Volvo Truck / Goldline/MT
RSMAD010079

Volvo Truck/Goldrare/MT-DG
REM0010589 左右上鏡座蓋
REM0010625

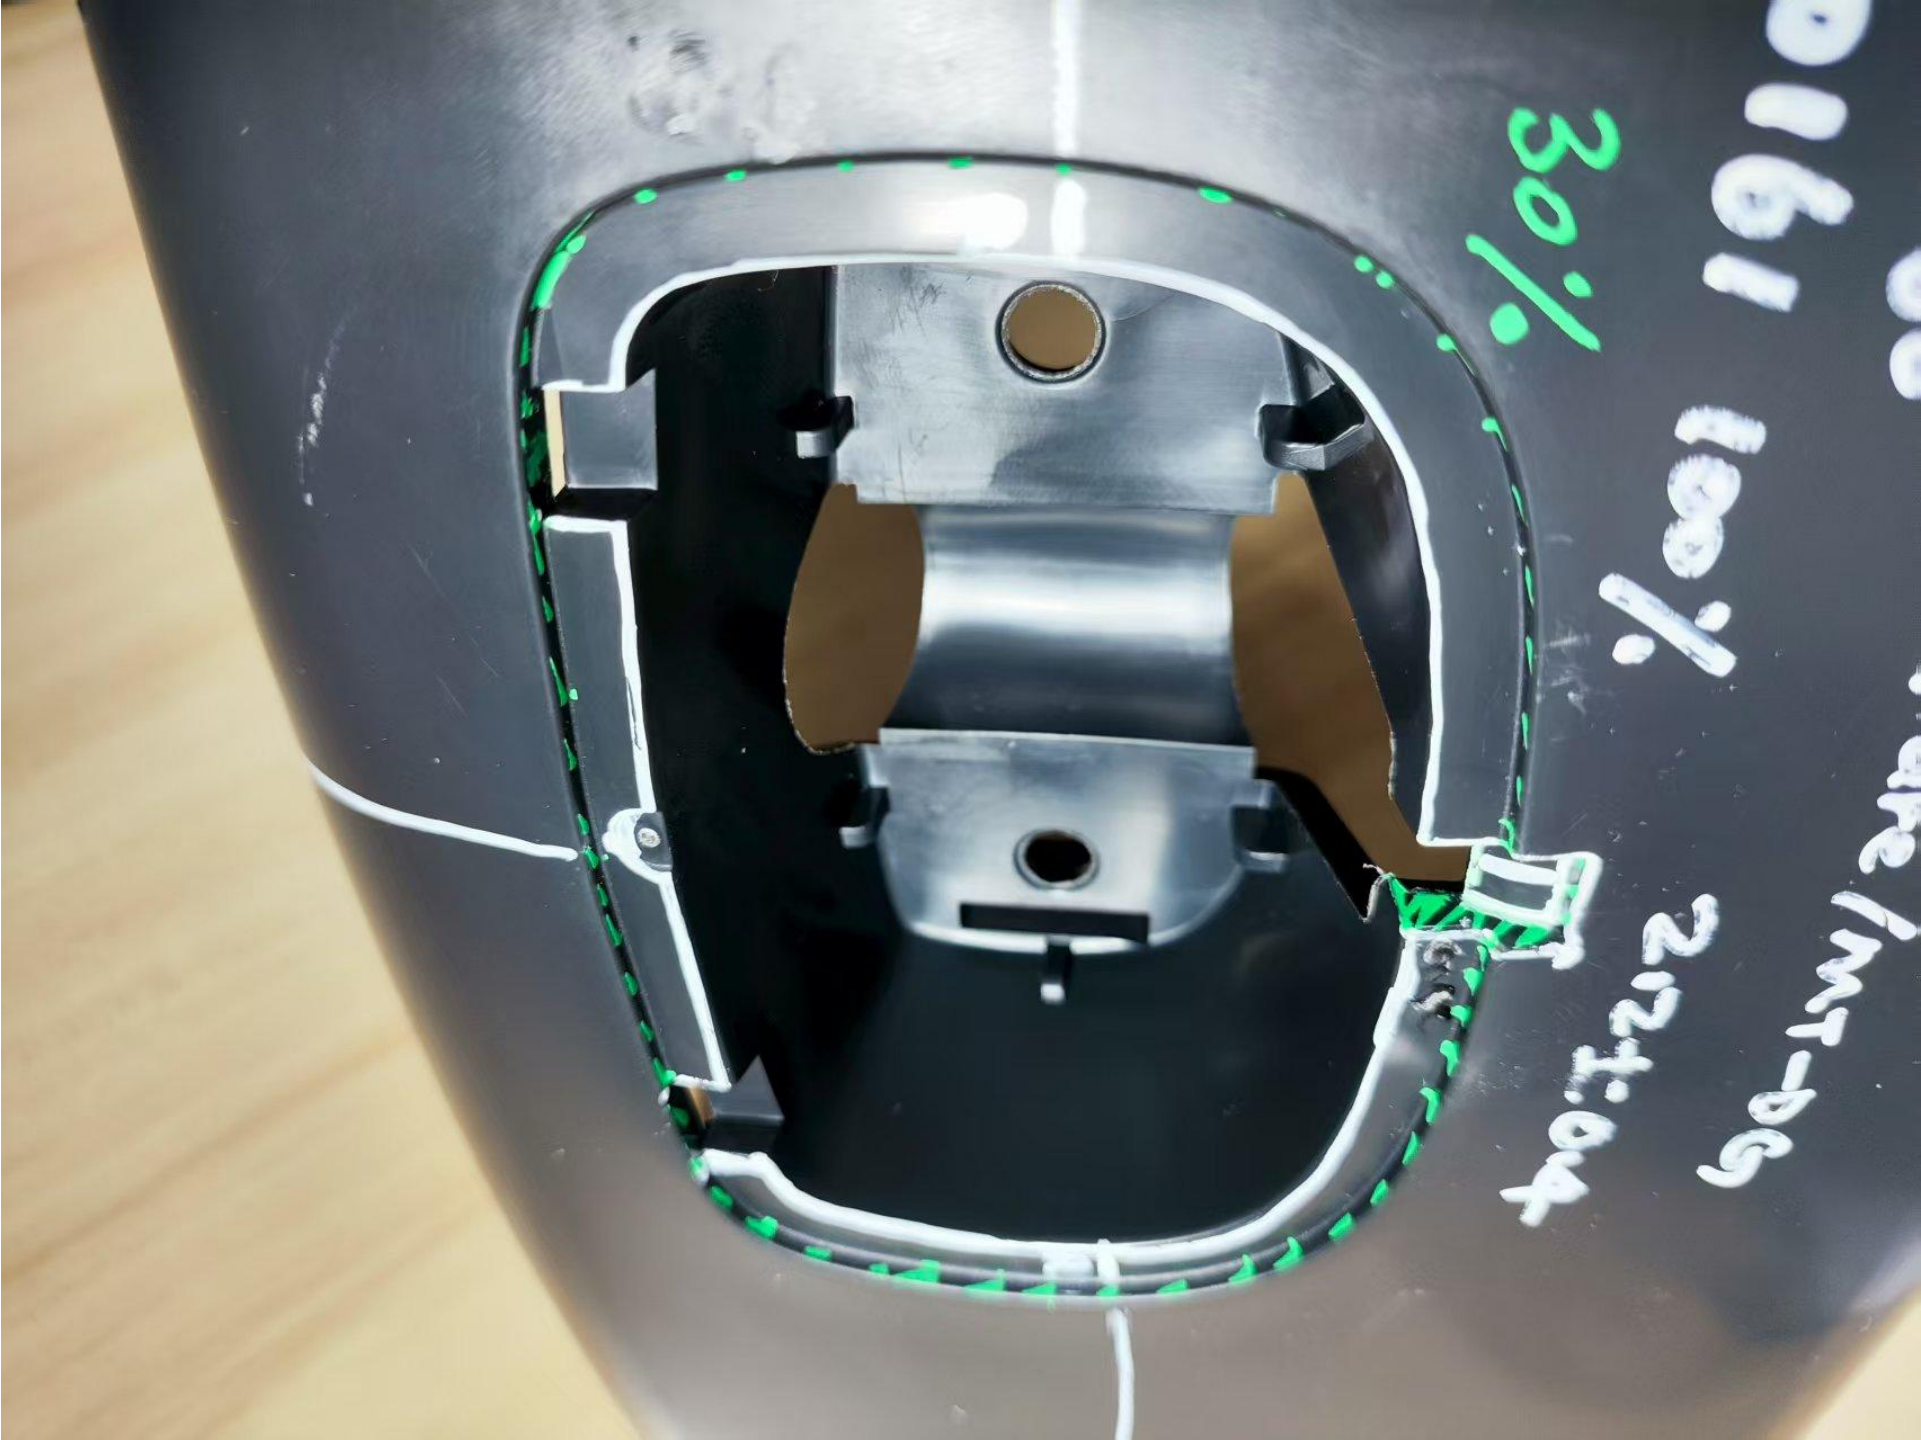
Flat seal off area need CNC scribe line by toolmaker, 0.3mm free band (border) to avoid the flash.

VT DQ: Reduced to 30% OK

左右主梁
田 3820161 100% 2.2 ± 0.4
田 3820161 80%

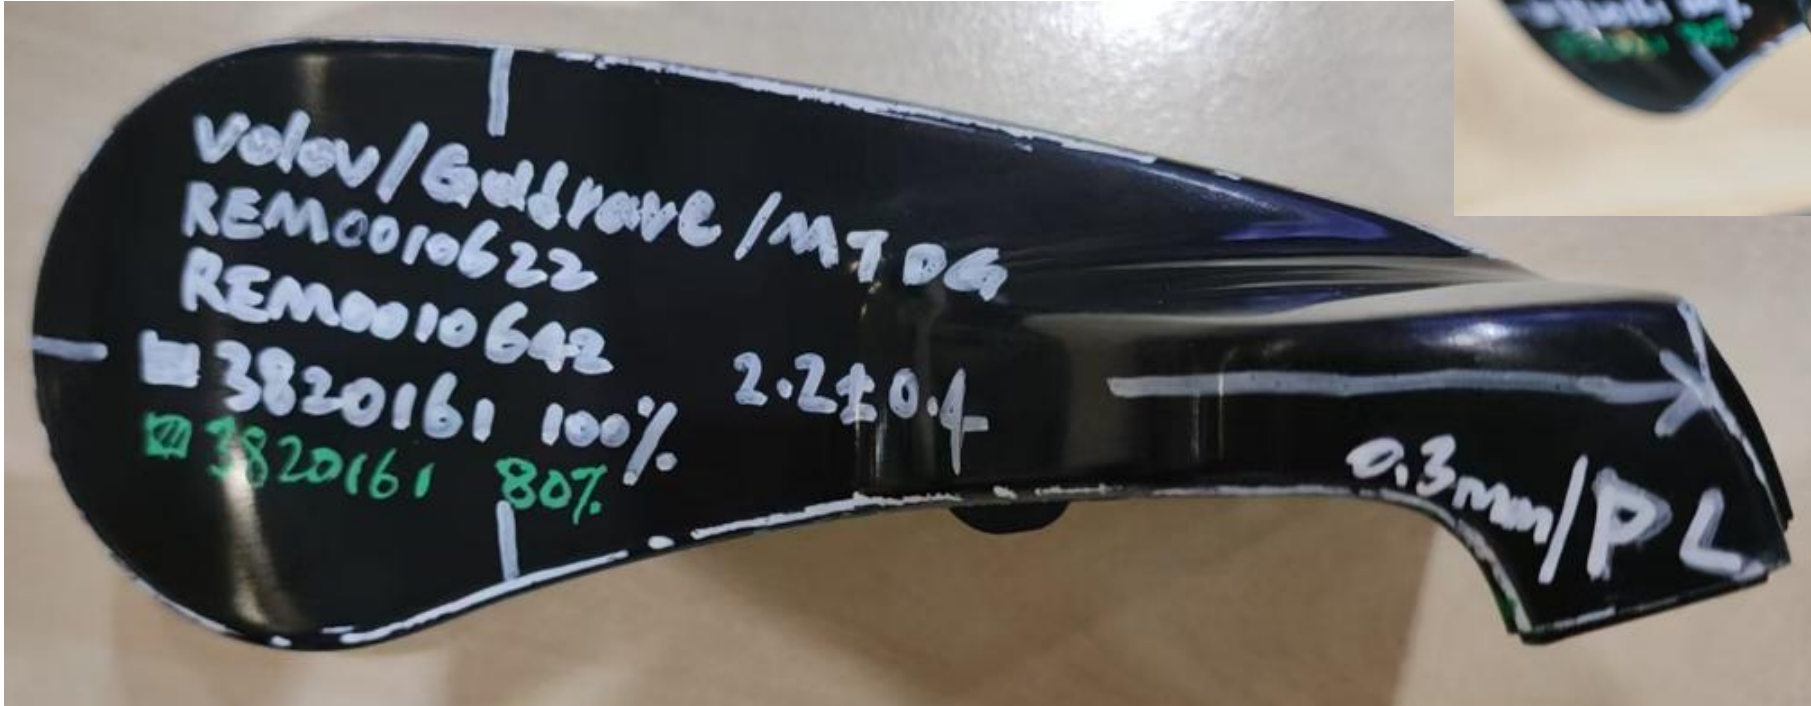
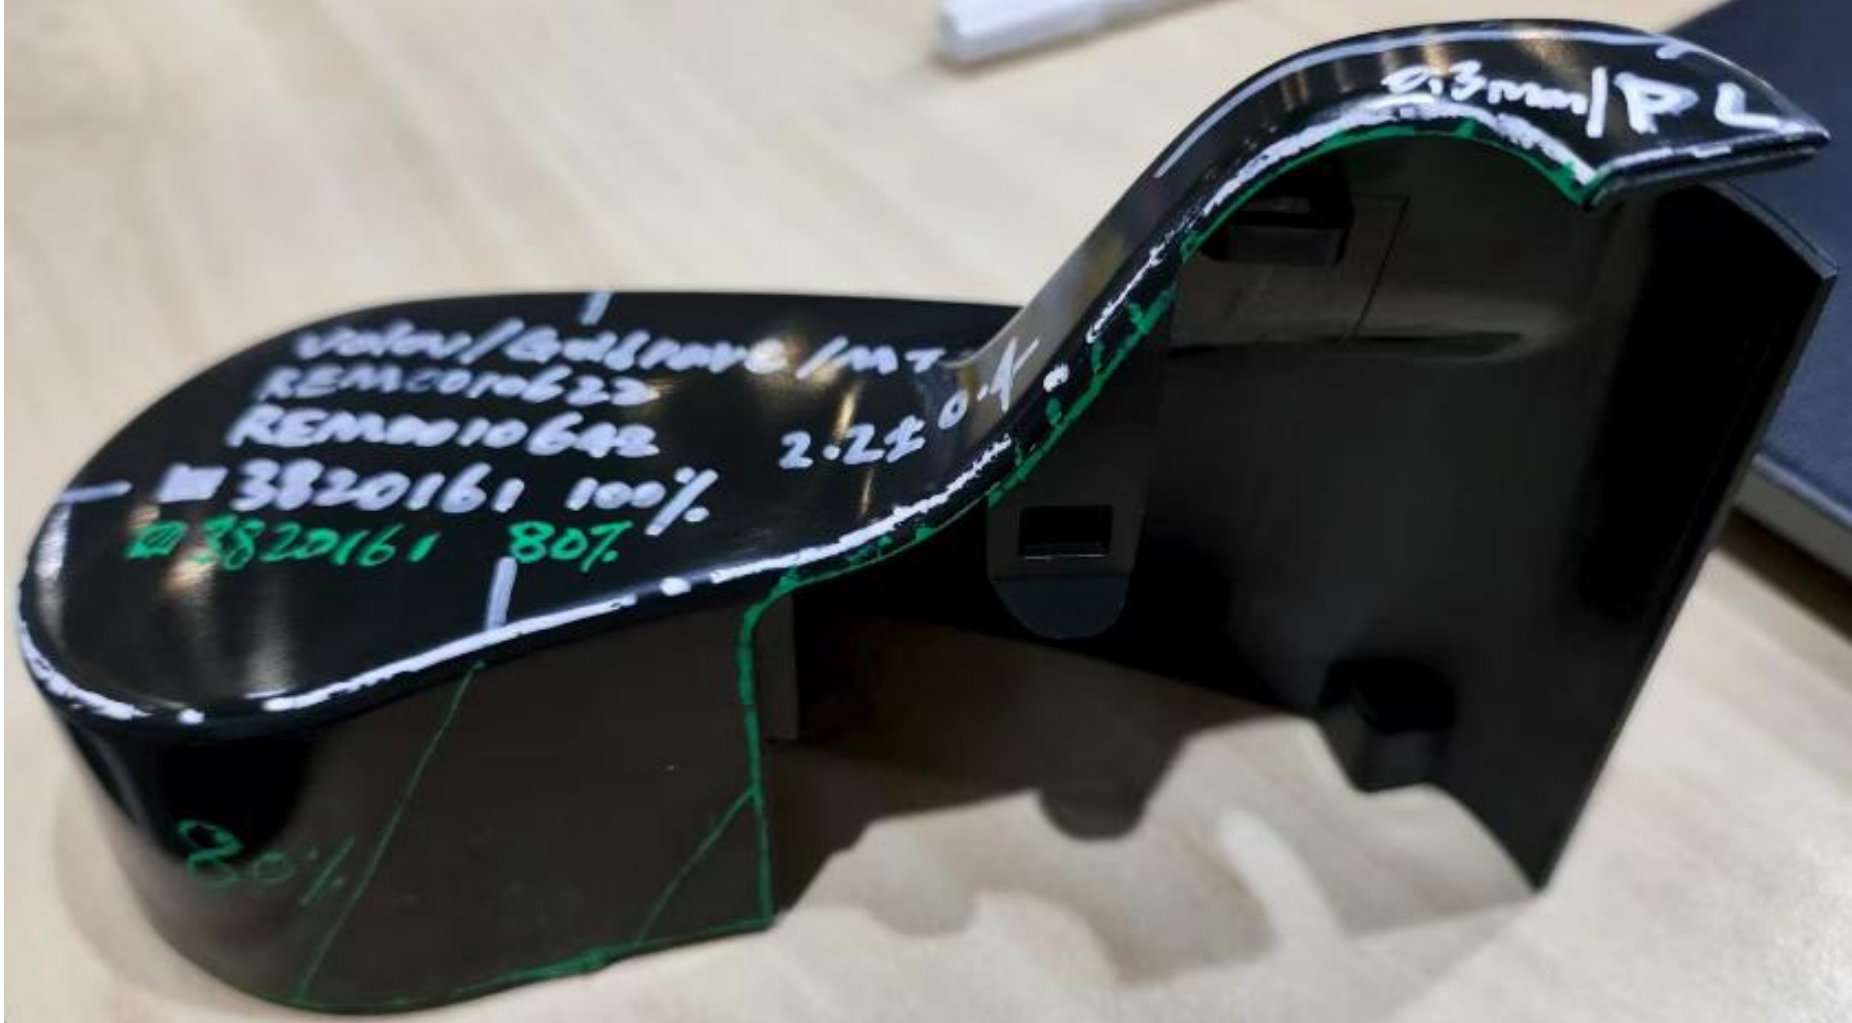
3820161 @ 100%
3820161@ 80%

VT DQ: Reduced to
80% OK

VT DQ: Reduced to 80% OK

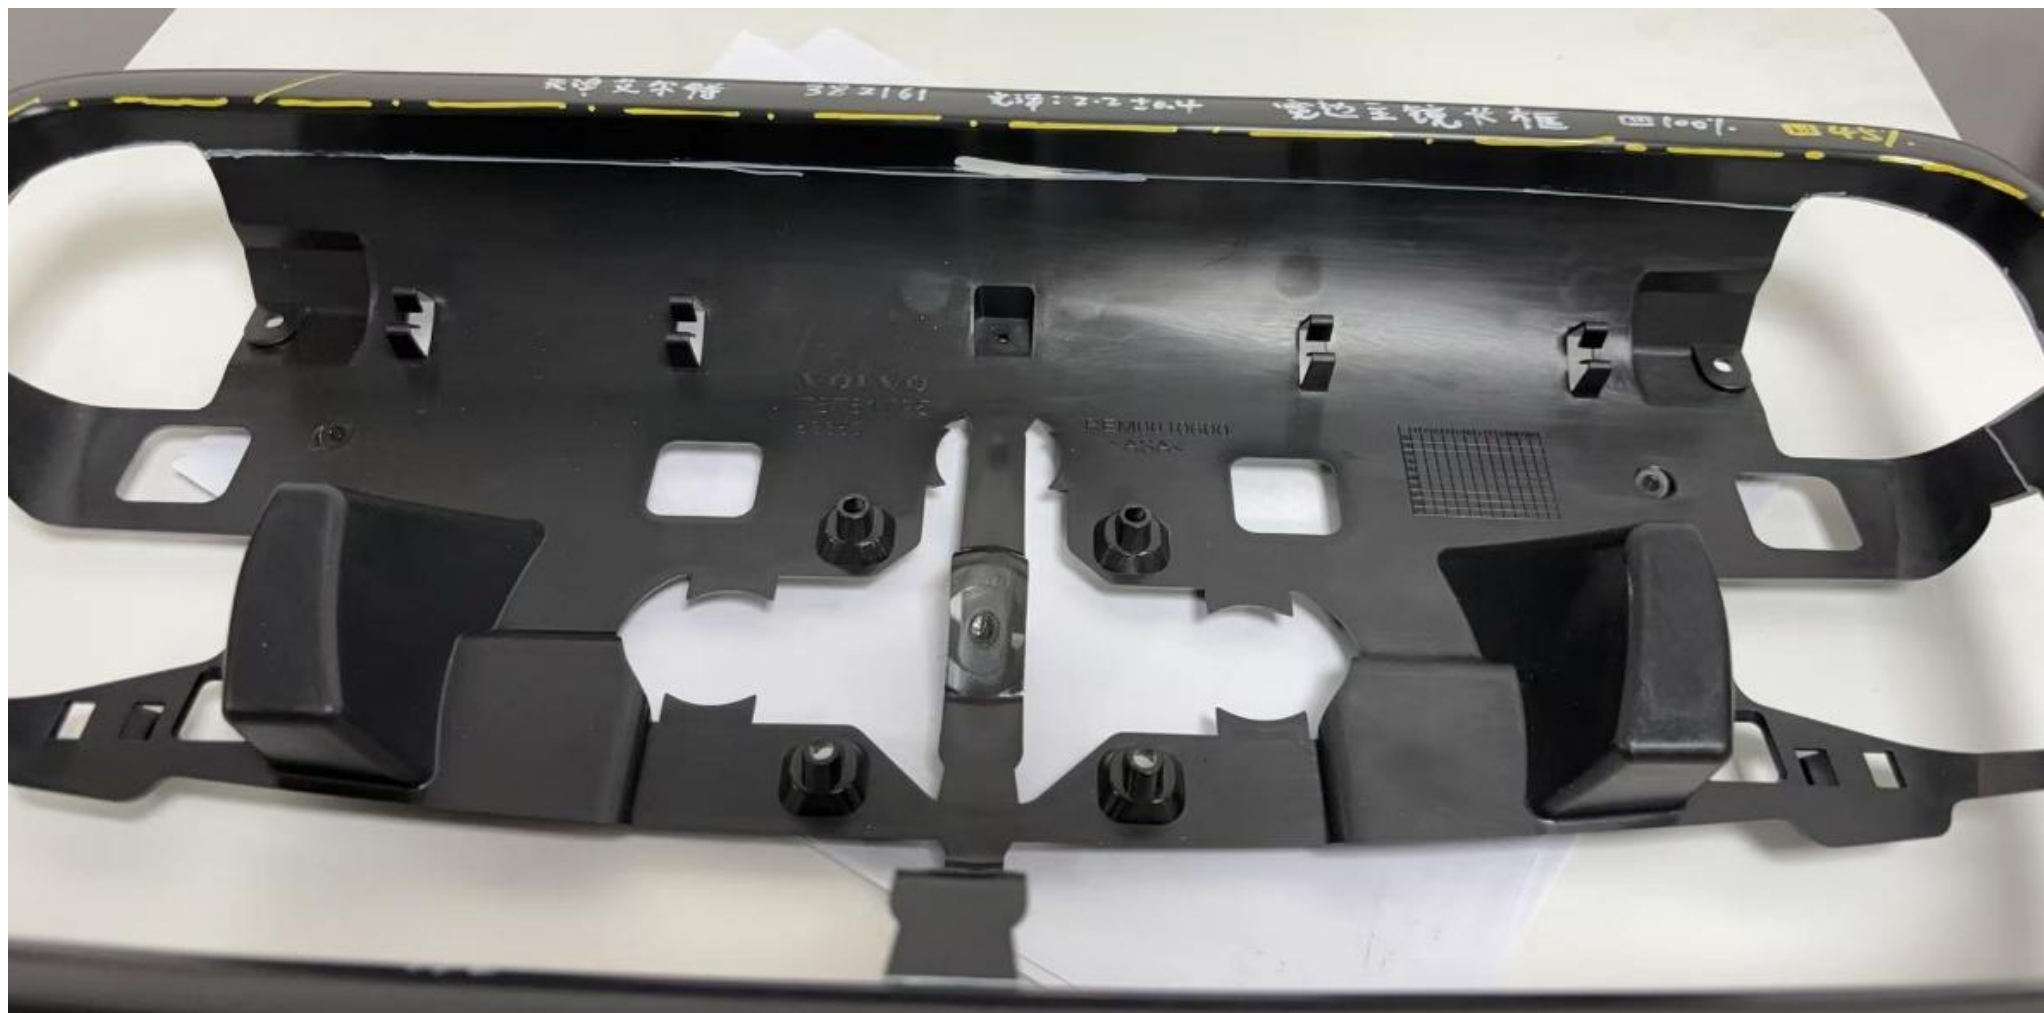
draft angle is 3 dgree , suggest 45%

VT DQ 25w42: Reduced to 45% OK
